Proposal for Amendment 4 of the Mutual Resolution No. 1 (M.R.1) of the 1958 and the 1998 Agreements *

Submitted by the Chair (Republic of Korea) of the Informal Working Group on the Deployable Pedestrian Protection Systems of UN Global Technical Regulation No. 9.

Addendum 5 – Specifications for the Qualification of Human Body Models for pedestrian Head Impact Time determination as a Deployable Pedestrian Protection Systems prerequisite

Figure 1.1
Flowchart showing the interaction between UN GTR No.9 Annex 2 and this M.R.1 Addendum.

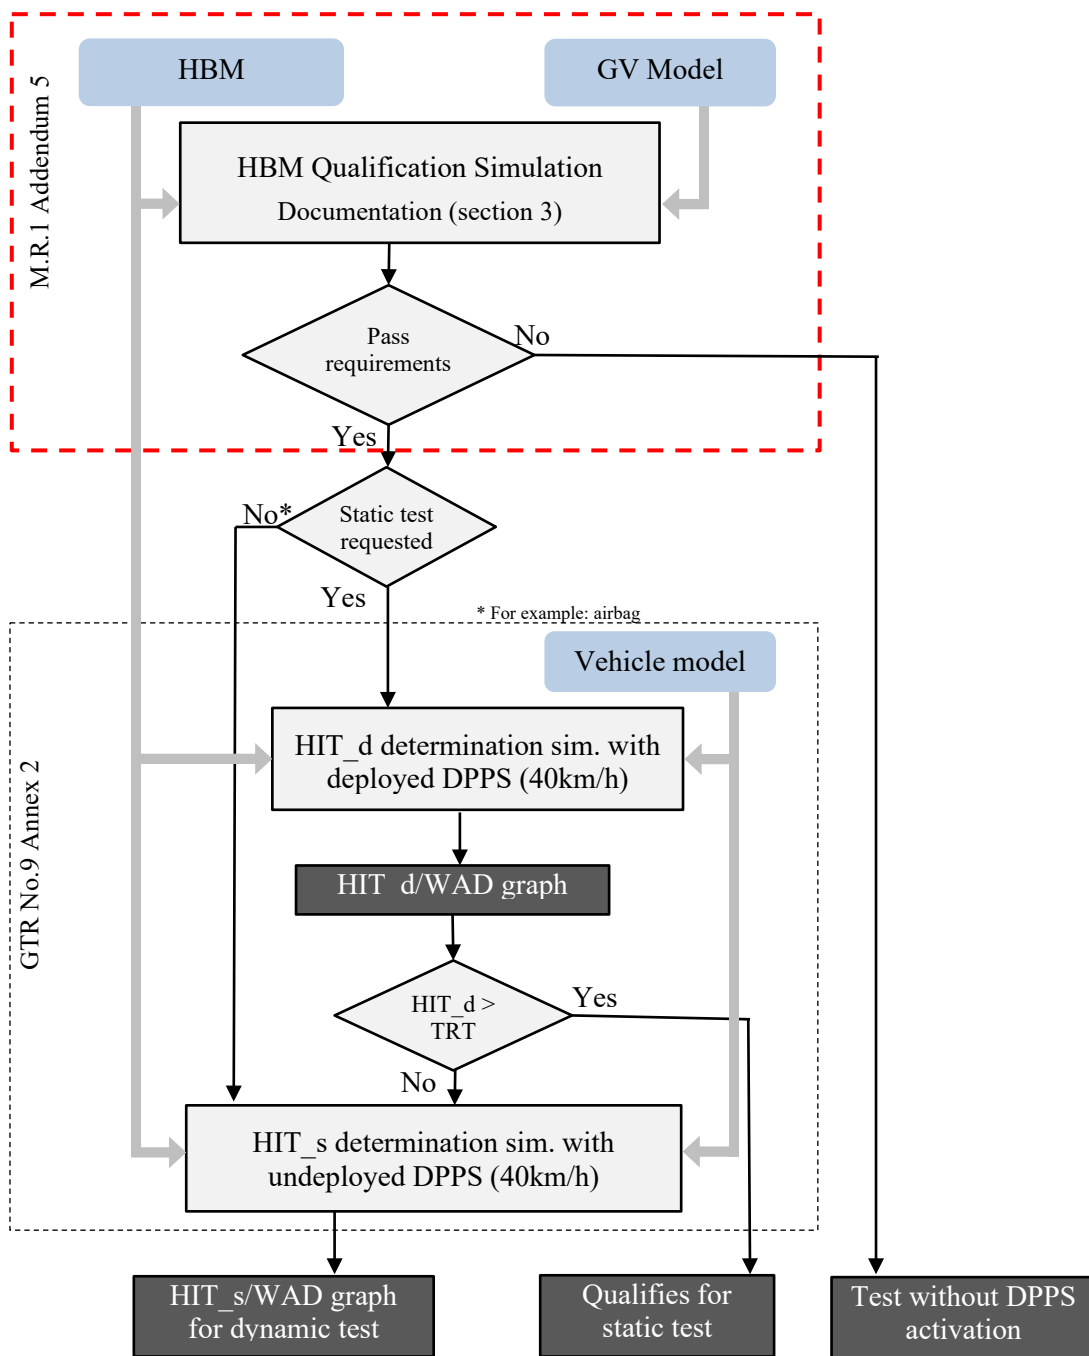
1. ~~Introduction~~ General Provisions

This Addendum provides the specifications for the Human Body Models (HBMs) related to the Head Impact Time (HIT) Determination Procedure defined in GTR No.9 Annex 2. The HBM qualification procedure and all related tools, as requested in Annex 1 of GTR No.9 are specified in this Addendum. ~~as part of the DPPS prerequisites.~~

~~HBM compliance shall be demonstrated in accordance with the qualification procedure in this document.~~

Figure A.6
Anatomic Landmarks of upper extremities

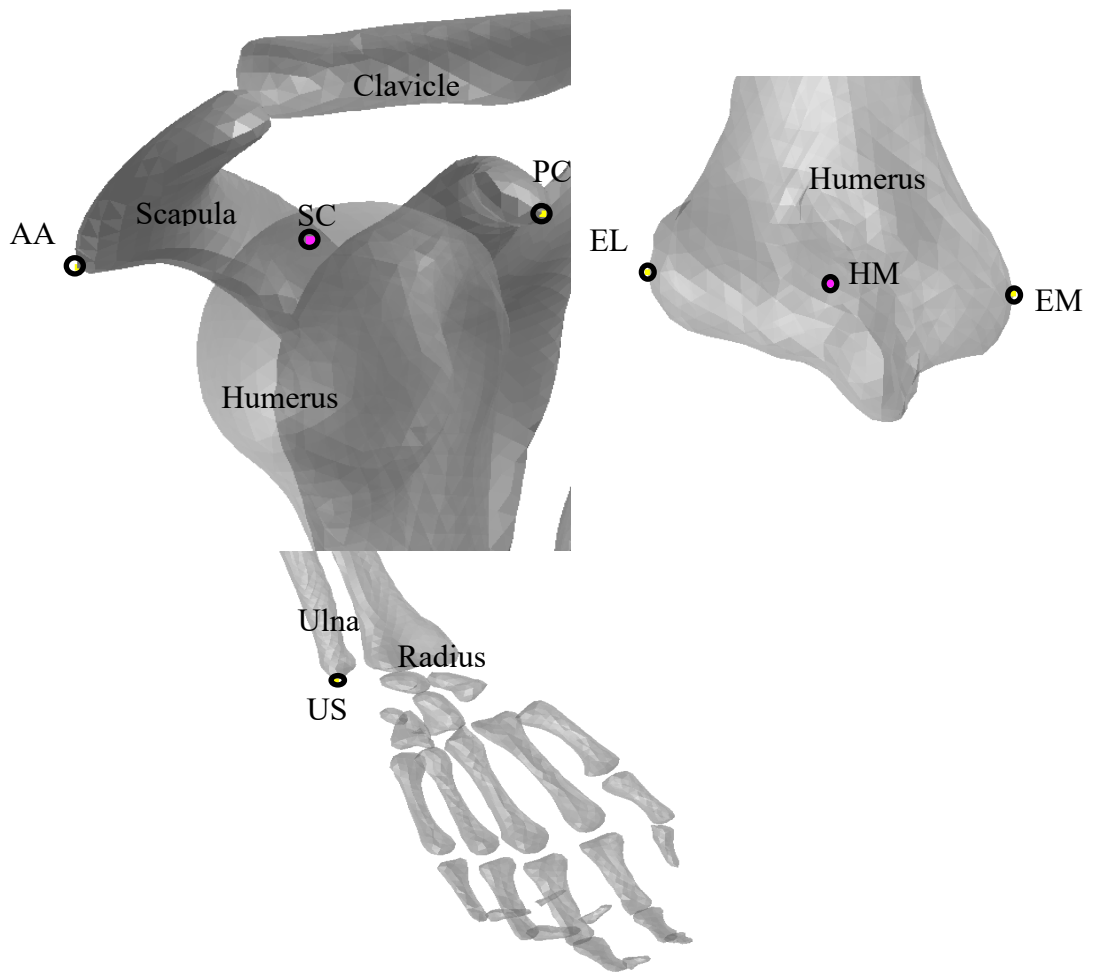
- (g) **The Upper Arm Angle is defined as angle around the Y axis between the horizontal plane and the humerus reference axis. The humerus reference axis is defined as the connection between the shoulder reference point (SC) and the Humerus reference point (HM). SC is determined as the midpoint of the most laterodorsal point of the Angulus Acromialis (AA) and the most ventral point of processus coracoideus on the scapula (PC), both on the scapula. HM is defined as the midpoint of the most caudal-lateral point on lateral epicondyle (EL) and the most caudal-medial point on medial epicondyle (EM). These points have to be defined on the left (SCL, HML) and right side (SCr, HMr) of the HBM (Figure A.6).**

- (h) **The Elbow Flexion Angle is defined as angle between the humerus reference axis and the connection between HM and the most caudal-medial point on the ulnar styloid (US). This axis has to be defined on the left (HML, USl) and right side (HMr, USr) of the HBM.**
